DGM-64-25 COW September 9, 2025
William Coutts presentation

100 Plains Rd

Review of the Recommendation Report
for Official Plan and Zoning By-law Amendment
for 100 Plains Road East

Figure 3.1

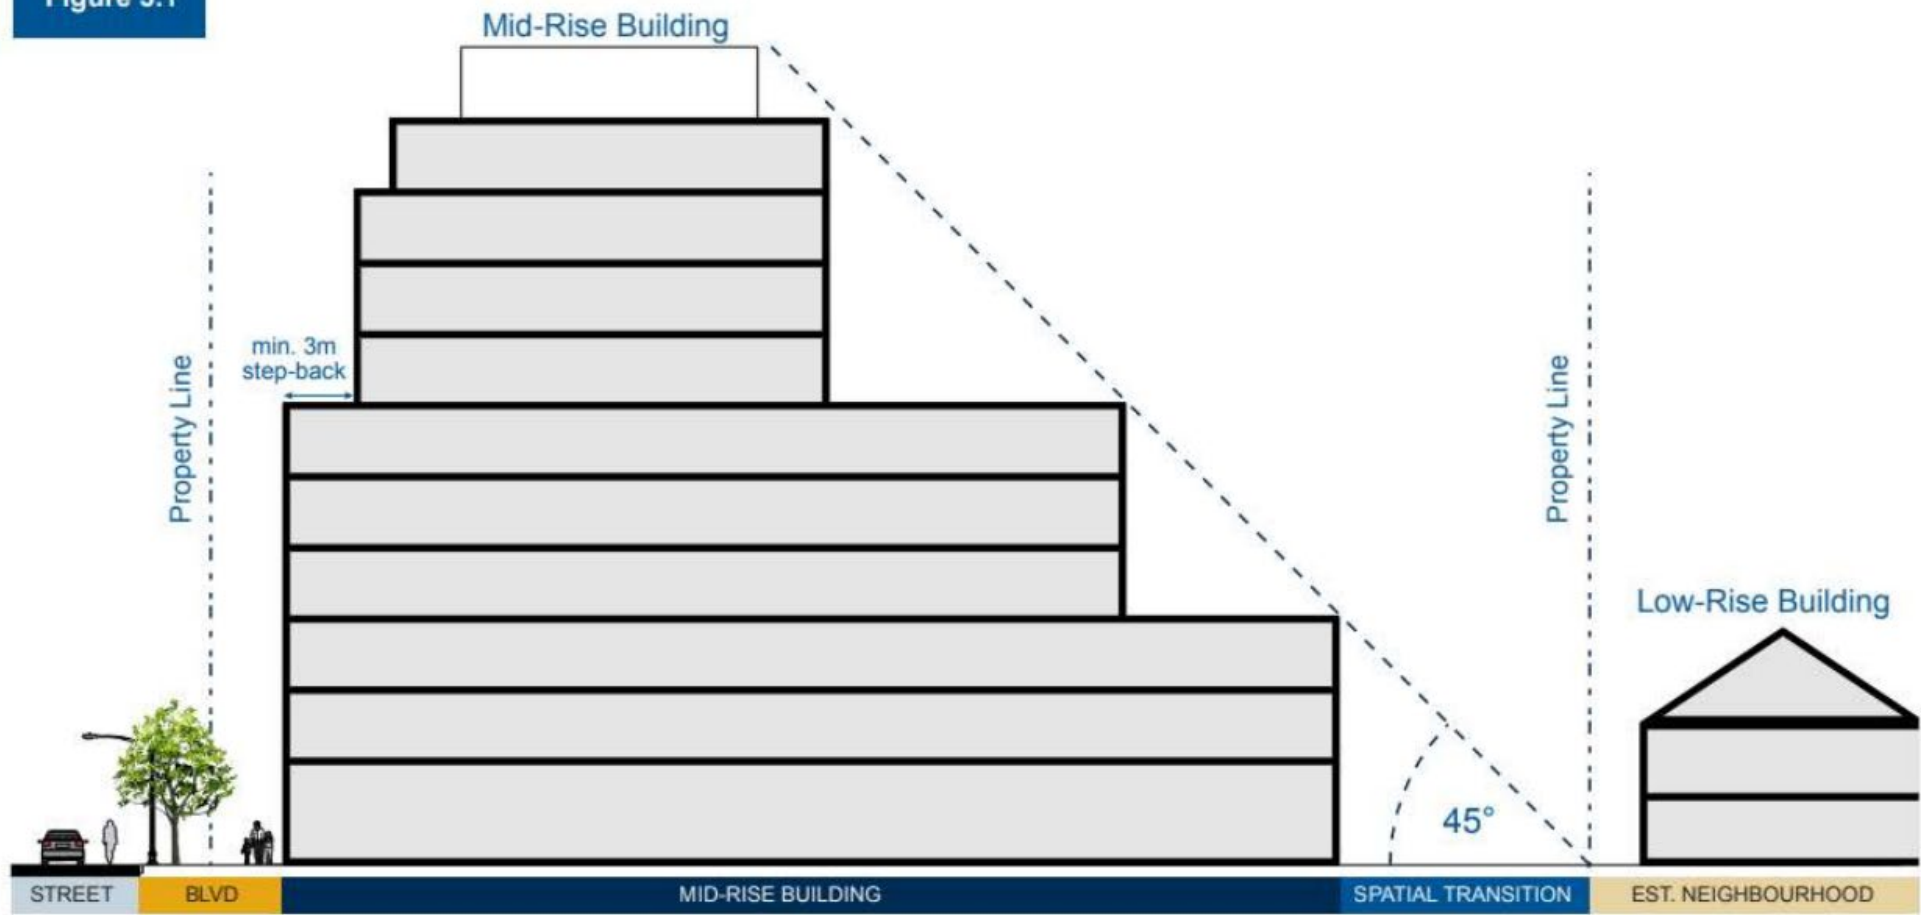
- 3. Where the building is on a site that is transitioning to a low-rise residential neighbourhood area (including properties designated Residential – Low Density and – Medium Density) a 45-degree angular plane should be applied from the shared property line. The building form should fit entirely within this angular plane and utilize setbacks and step-backs to ensure any impacts related to the change in height, overlook, and shadowing, and pedestrian level wind impacts are mitigated.*

The *Revised* Angular Plane Diagram

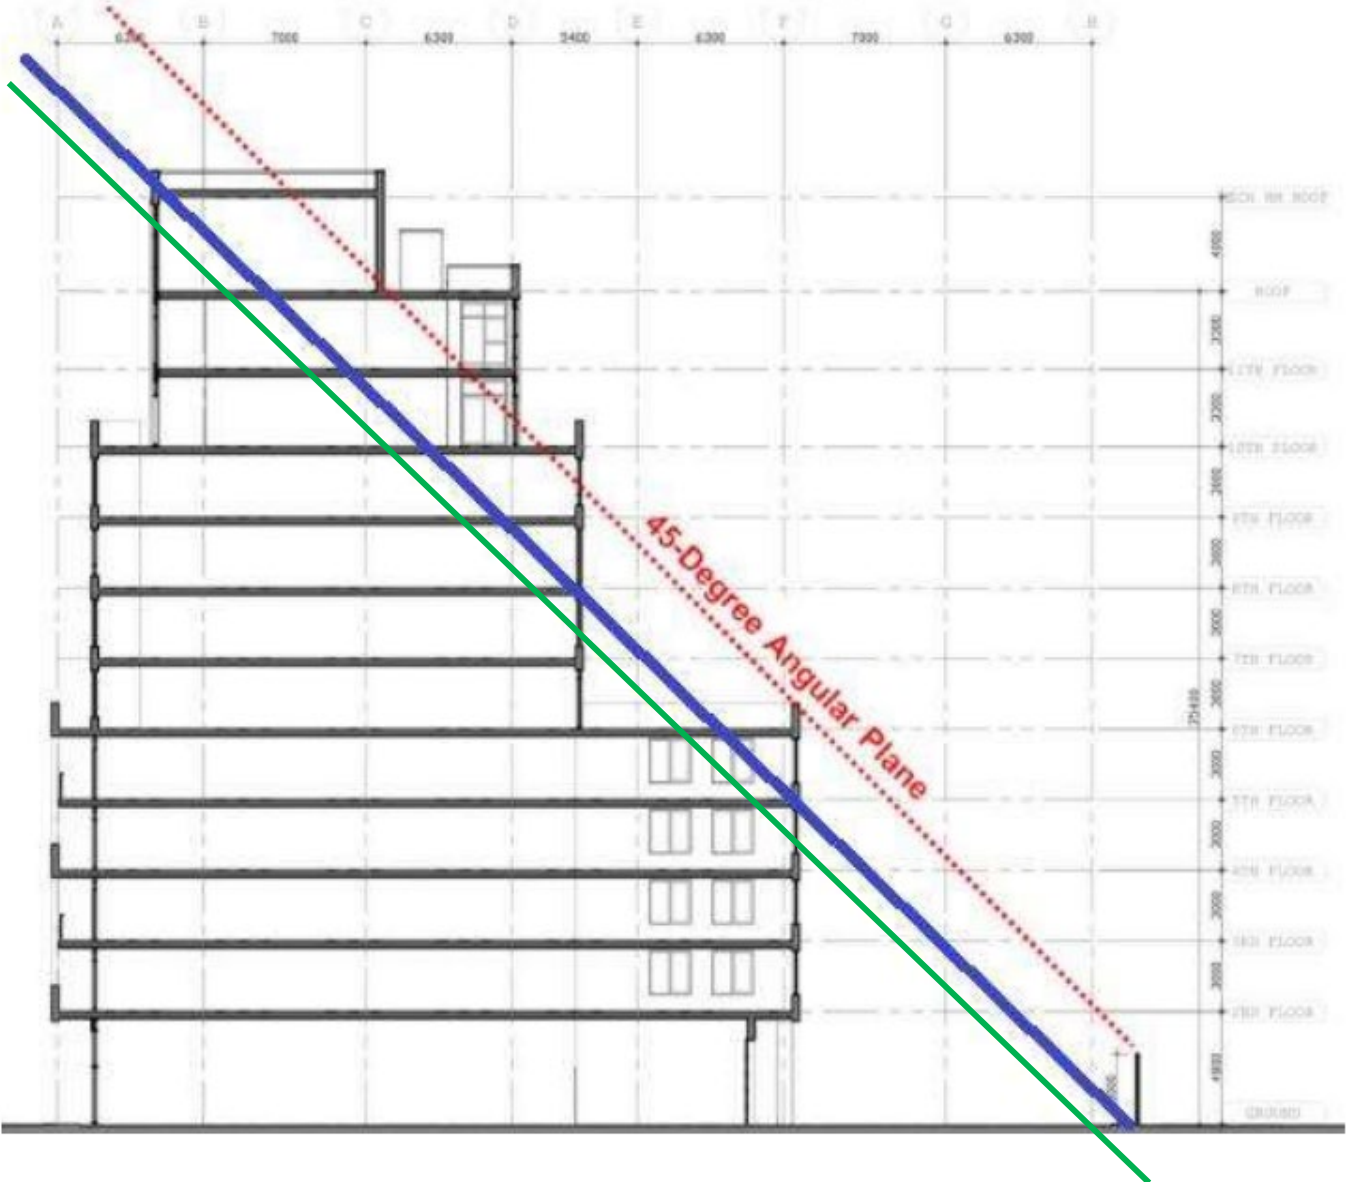
The proposed development also abuts a low-rise residential neighbourhood uses to the rear property line. As previously mentioned, the initial application submission the applicant provided a 45-degree Angular Plane diagram measured from the top of the fence along the rear property line. Subsequently, staff requested that the applicant provide a revised Angular Plane diagram measured from fixed grade from the rear property line. Staff were able to confirm that the proposed building is generally found within the 45-degree Angular Plane. Staff is of the opinion that although sections of the building encroach into the 45-degree angular plane, impacts of potential overlook into the neighbouring properties to the rear are mitigated by way of the proposed 2.8m landscape buffer and proposed 3m high fence which have been incorporated into the Zoning By-law.

The balconies are missing

5. *Balconies and other projections should be contained within all angular planes and setbacks and shall not protrude into the public realm (over sidewalks).*

Proposed Mitigation

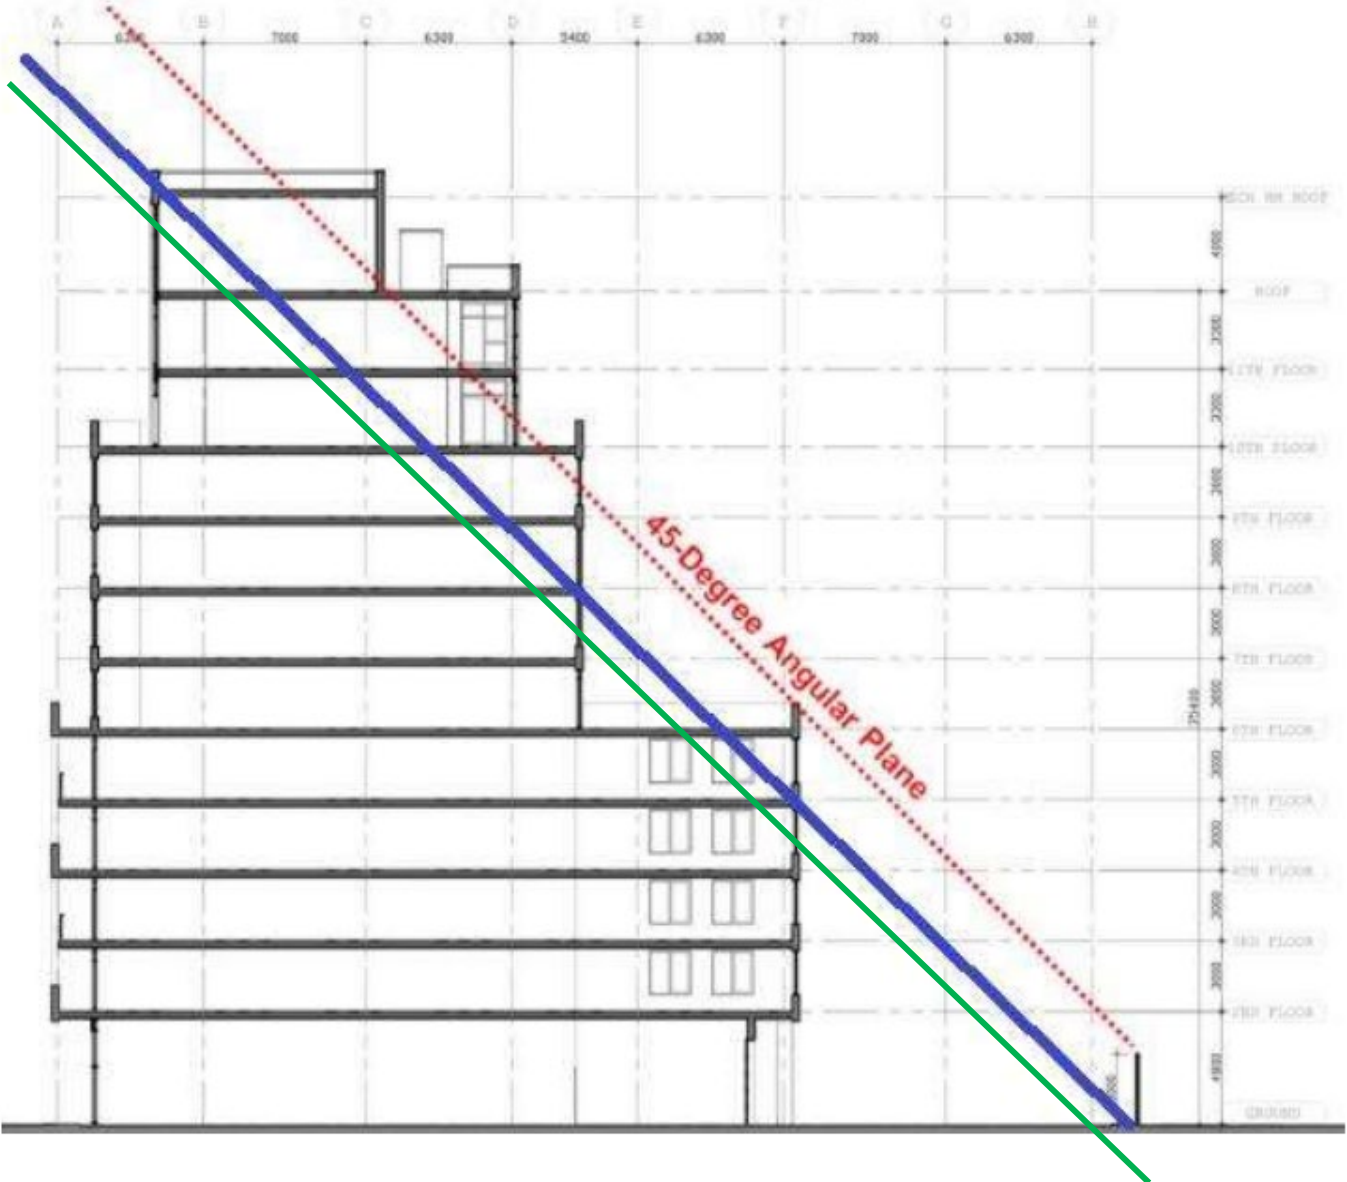
The proposed development also abuts a low-rise residential neighbourhood uses to the rear property line. As previously mentioned, the initial application submission the applicant provided a 45-degree Angular Plane diagram measured from the top of the fence along the rear property line. Subsequently, staff requested that the applicant provide a revised Angular Plane diagram measured from fixed grade from the rear property line. Staff were able to confirm that the proposed building is generally found within the 45-degree Angular Plane. Staff is of the opinion that although sections of the building encroach into the 45-degree angular plane, impacts of potential overlook into the neighbouring properties to the rear are mitigated by way of the proposed 2.8m landscape buffer and proposed 3m high fence which have been incorporated into the Zoning By-law.

The Panel raised concerns about the proposed buffer provided for the residential low-rise to the south, noting that it is quite narrow.

The Panel expressed concern that the current massing and parking configuration is maximized on site, leaving little room for the residents to the south.

Steps-back 0.8m

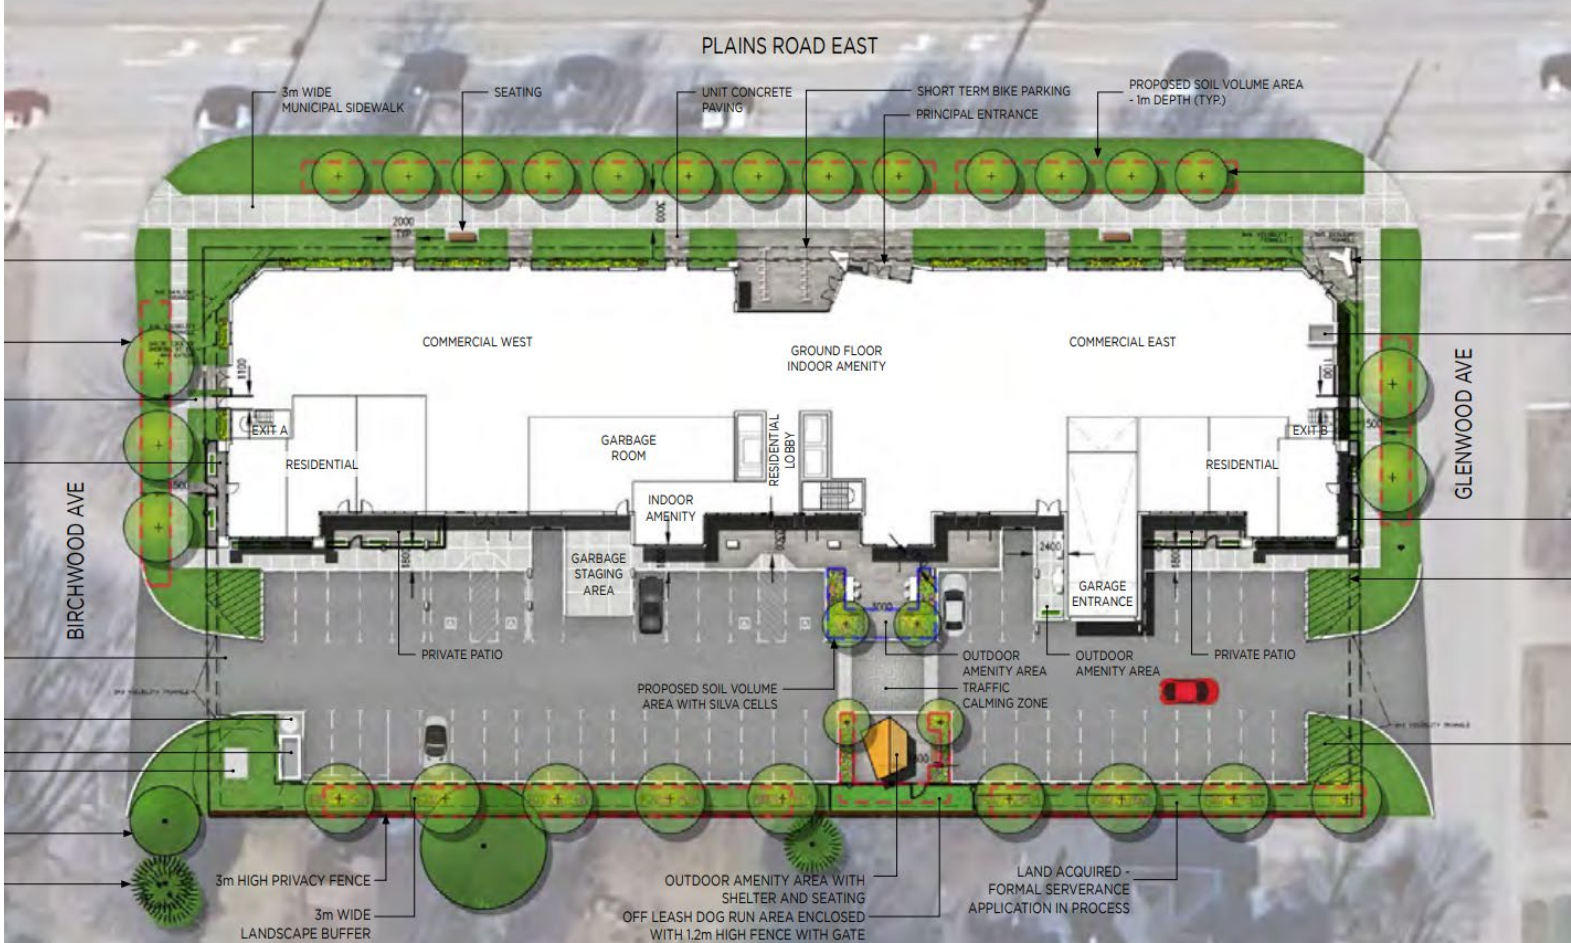
towards the Aldershot GO station. The intent of regulating maximum heights for the lower portion of mid-rise buildings is to achieve human scale and pedestrian feel along the streetscape. The proposed lower building portion includes step-backs along the west, east and south elevations at the 6th, 8th and 10th storeys, at approximately 16.8m, 22.8m and 28.8m in height measured from fixed grade, to provide for building design articulation.

- 5. Where a streetwall is not established, the streetwall for new mid-rise buildings should be limited to a height of 80% of the street width (up to a maximum of 6-storeys) with additional storeys stepping-back a minimum of 3 metres above the streetwall to maintain a humanscale and minimize shadowing. On streets with a*

Steps-forward, not back

Appendix C - Multifamily Housing (High Rise) Close to Rail Transit A Small Sample

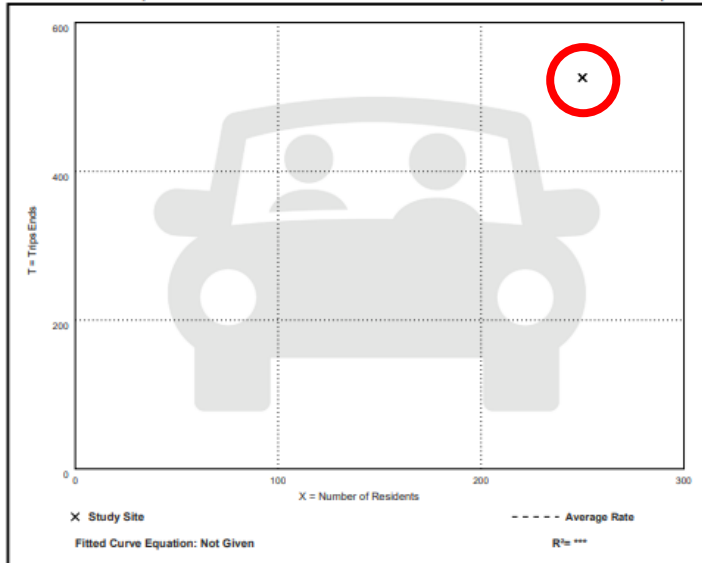
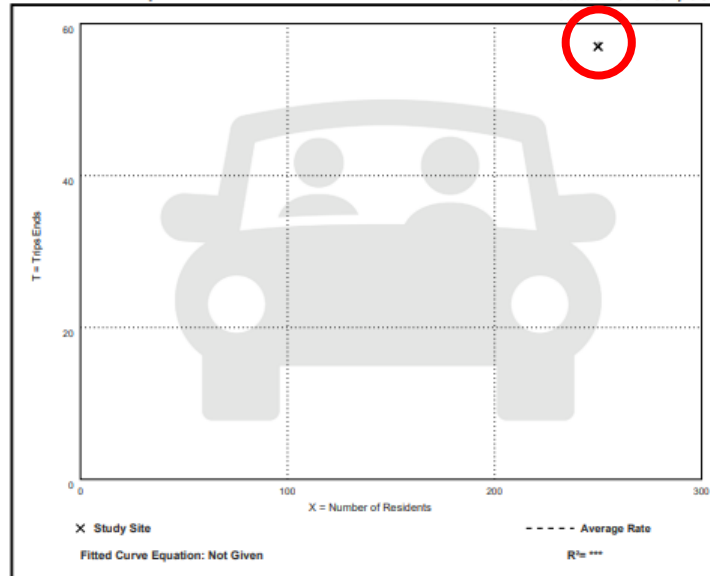
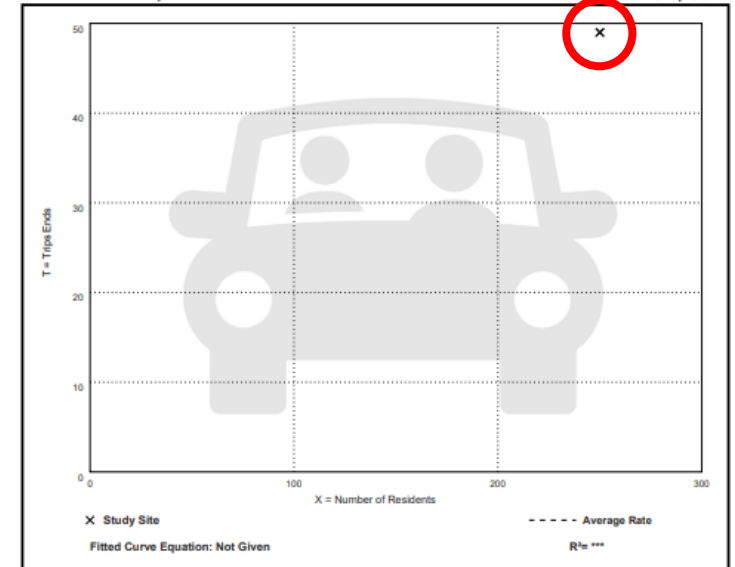
Caution - Small Sample Size

Caution - Small Sample Size

Caution - Small Sample Size

The sites were surveyed in the 1980s, the 2000s, and the 2010s in California, District of Columbia, Maryland, New Jersey, New York, Ontario (CAN), Oregon, Pennsylvania, and Virginia.
